"4TH COMMUNITY MEETING"

February 2, 2017

BAR CONCEPT REVIEW

COMMENTS

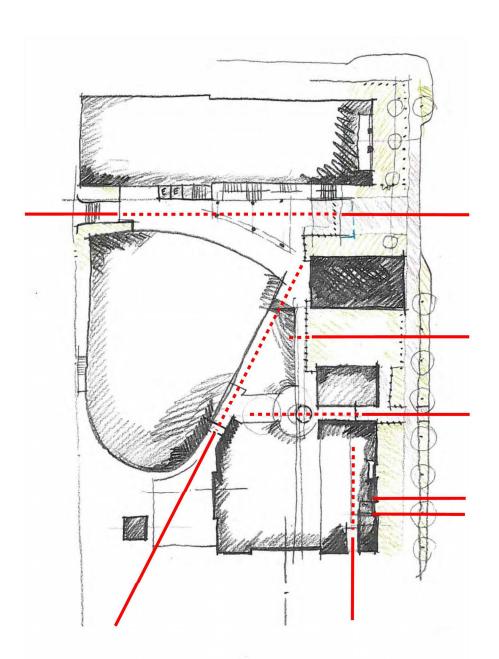
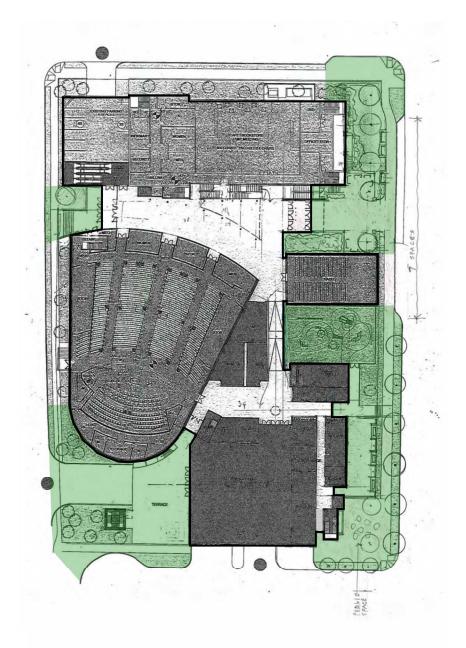
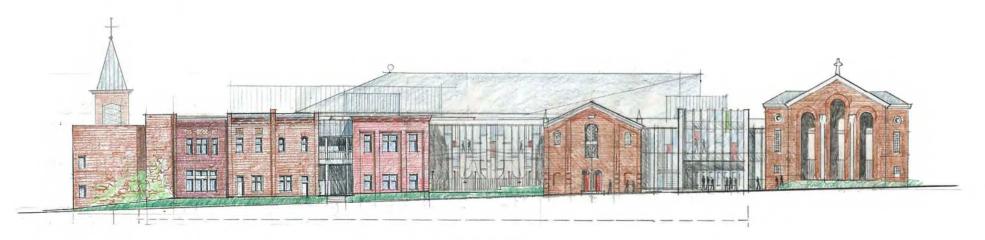
In summary, the Board supported the height, scale, mass and general architectural character as submitted with direction to the applicant to continue to work on the following:

- Increase the site's physical and/or visual porosity, building on the design parti of a collection
 of separate buildings on the site.
- Emphasize a sense of entry on Alfred Street and also refine the townhouse character on South Alfred Street.
- Restudy the roof form at north end of the sanctuary above the balcony to eliminate the vertical, triangular roof/wall.
